RE: STATUS REPORT ON PROPOSED GVS&DD INCINERATION FACILITY
BURNABY'S BIG BEND INDUSTRIAL AREA

TO: MUNICIPAL MANAGER 1984 December 04
FROM: DIRECTOR PLANNING & BUILDING INSPECTION Our file: 15.601.1
SUBJECT: STATUS REPORT ON PROPOSED GVS&DD INCINERATION FACILITY
BURNABY'S BIG BEND INDUSTRIAL AREA

FIGURE A

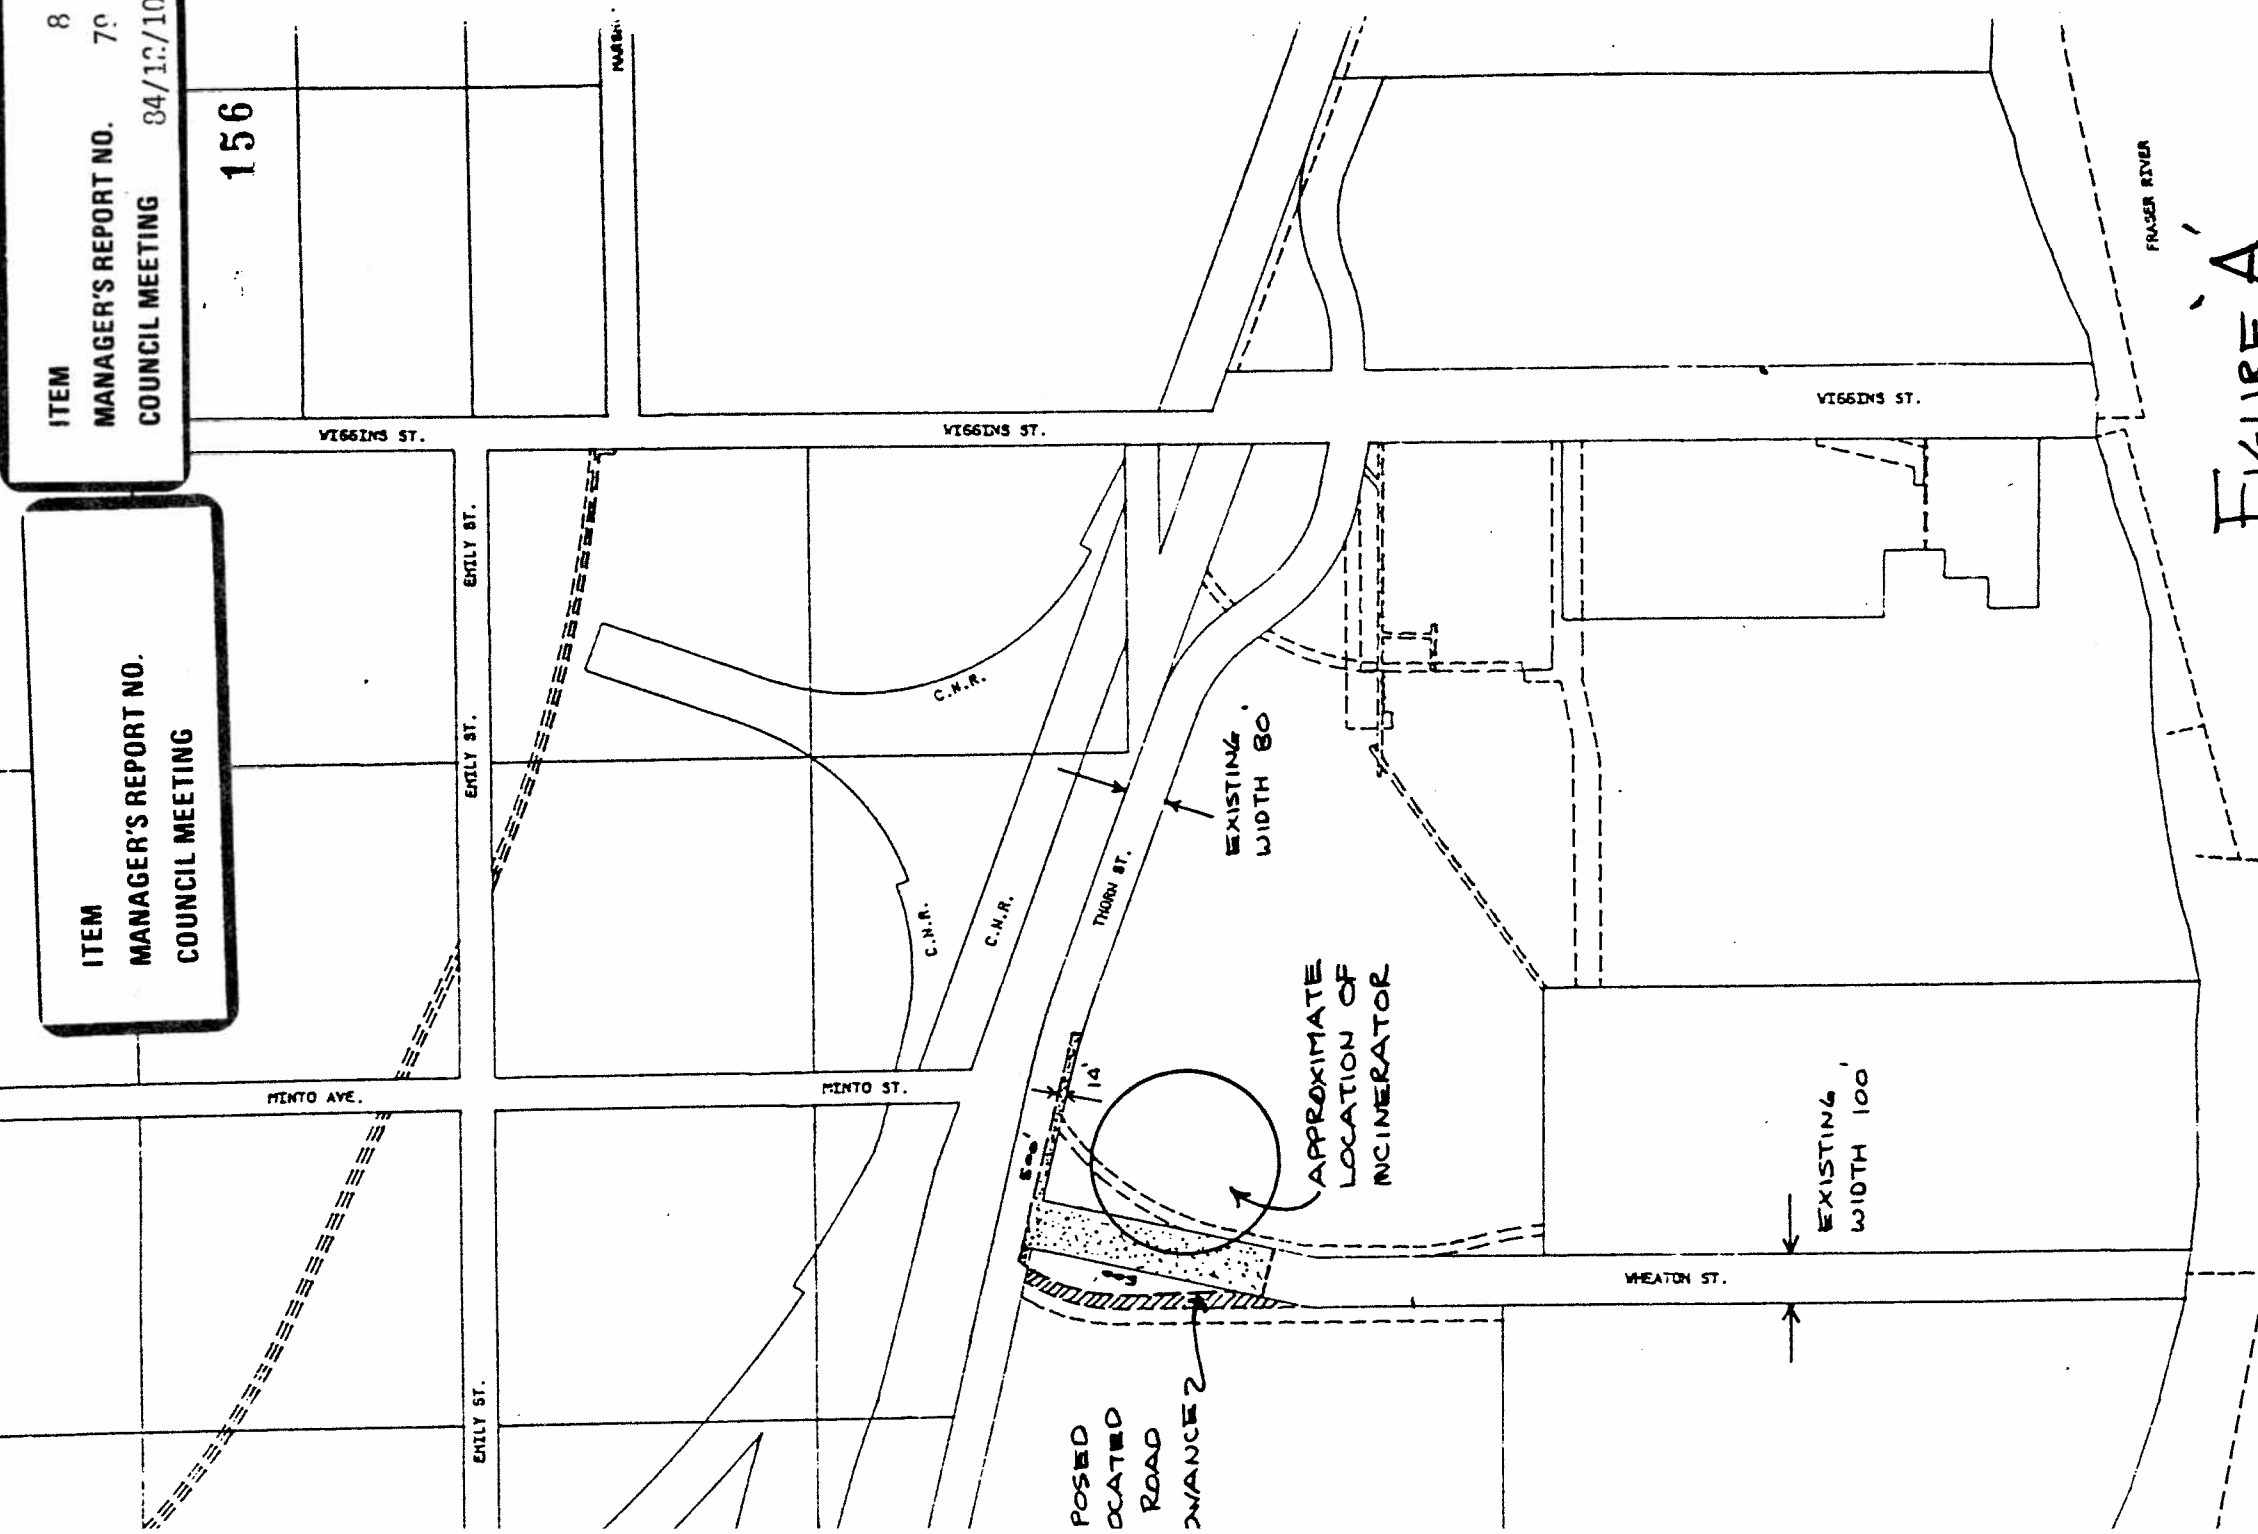
Council has previously been advised that several sites were under review in close proximity to the Belkin Paperboard plant at the foot of Wiggins Street in Burnaby's Big Bend Area, with preference being given to acquiring property from Belkin Paperboard. The GVS&DD had requested the Planning and Building Inspection Department to pursue the possibility of closing portions of the Thorne Street and Wheaton Street road allowances for inclusion in the incinerator site as illustrated on the attached Figure A.

FIGURE 'B'

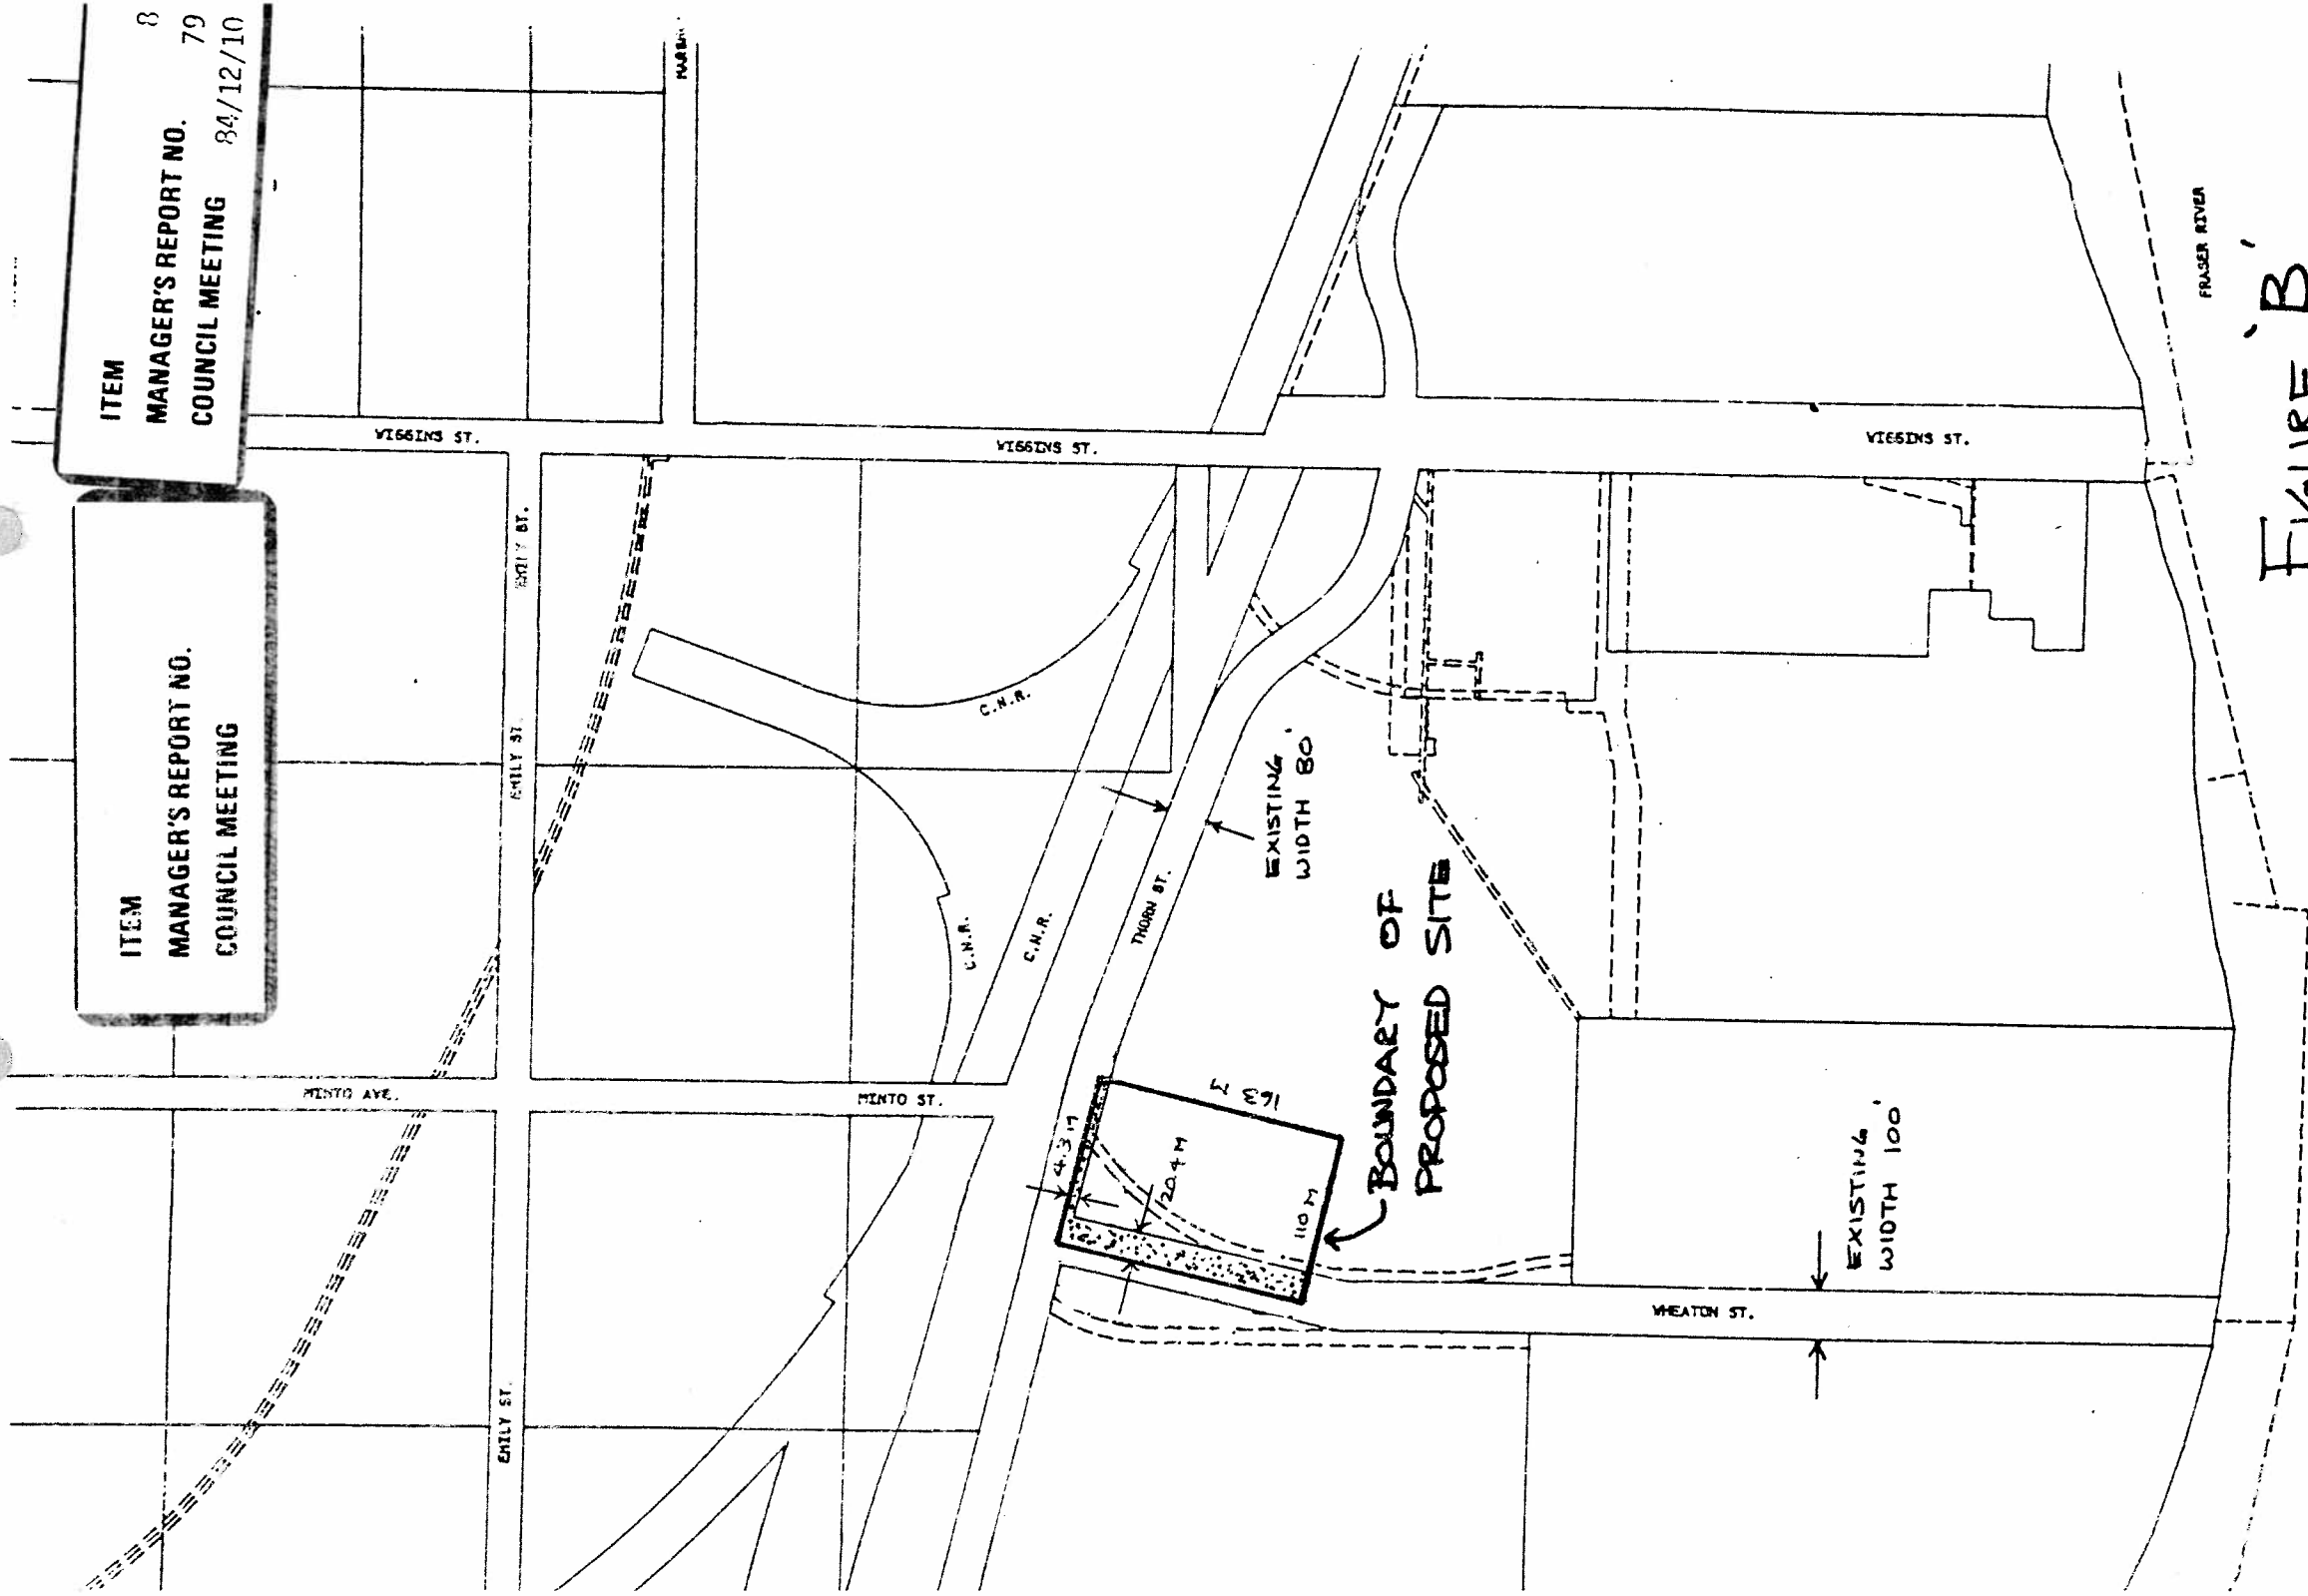
As noted in the following section, Belkin Paperboard has agreed to participate in the project and, therefore the specifications for the performance, design features and operating requirements for the plant have now been drawn up for the Belkin site. The area of the redundant road allowances proposed for inclusion in the site has been revised as shown on the attached Figure B.

FIGURE C

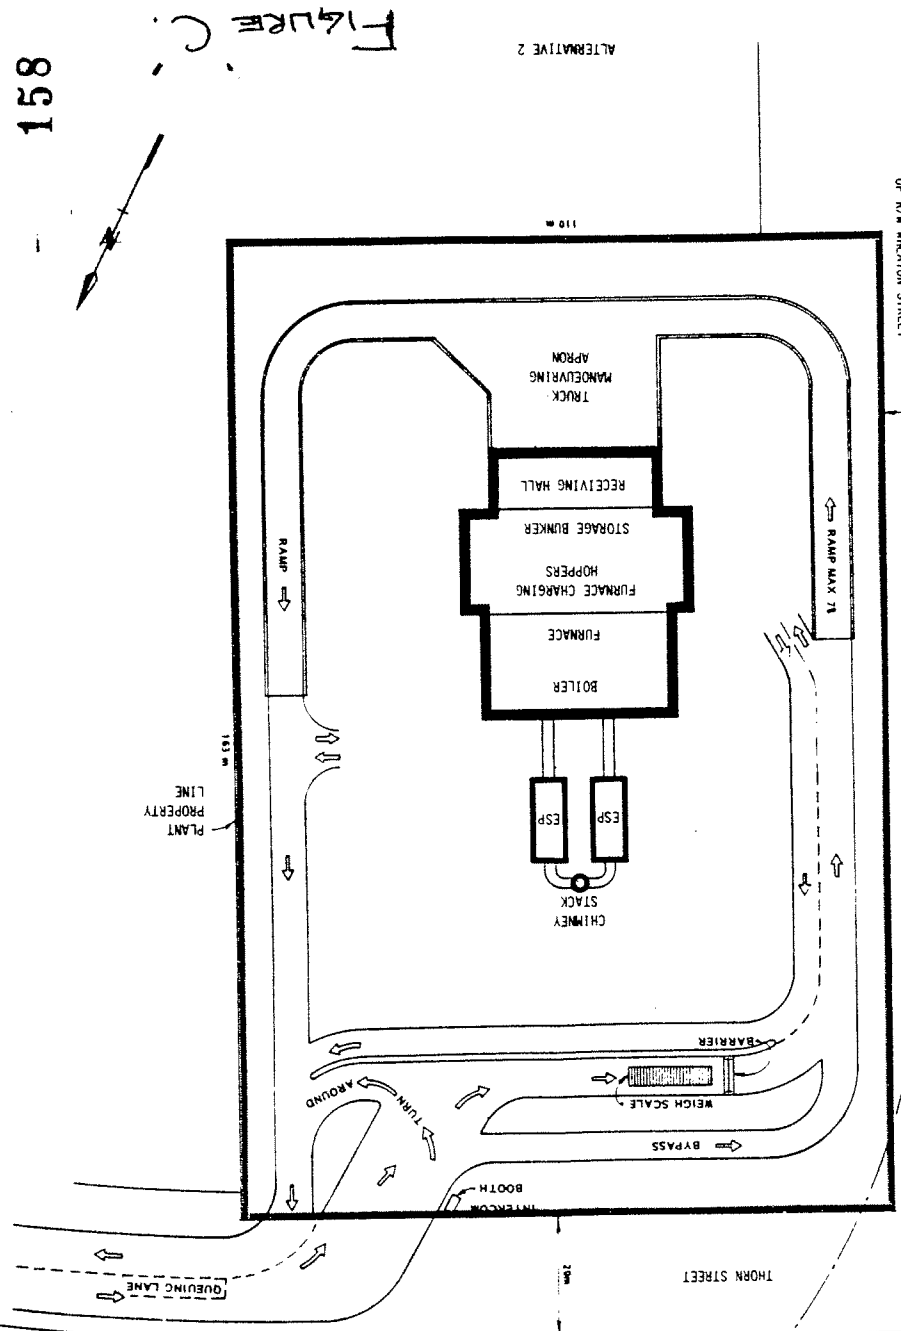
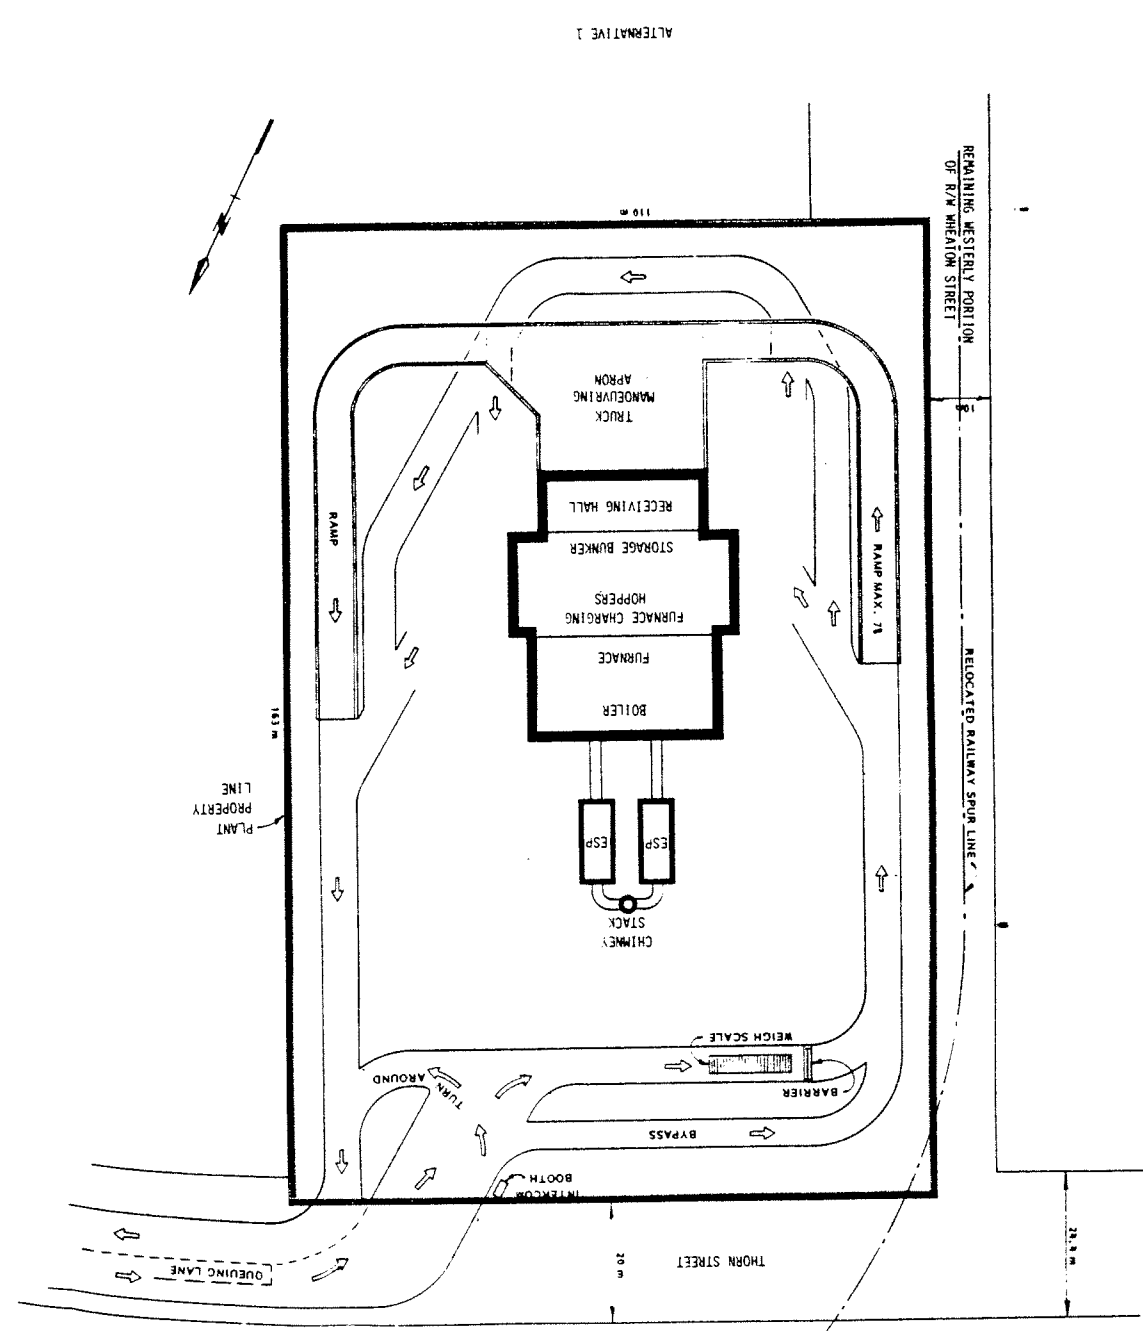
The actual plant will occupy a relatively small part of the 1.8 ha site. Plan SF-1749, Sketch 14, (Figure C attached) which sets out principles for arrangement of access and roads, illustrates this.
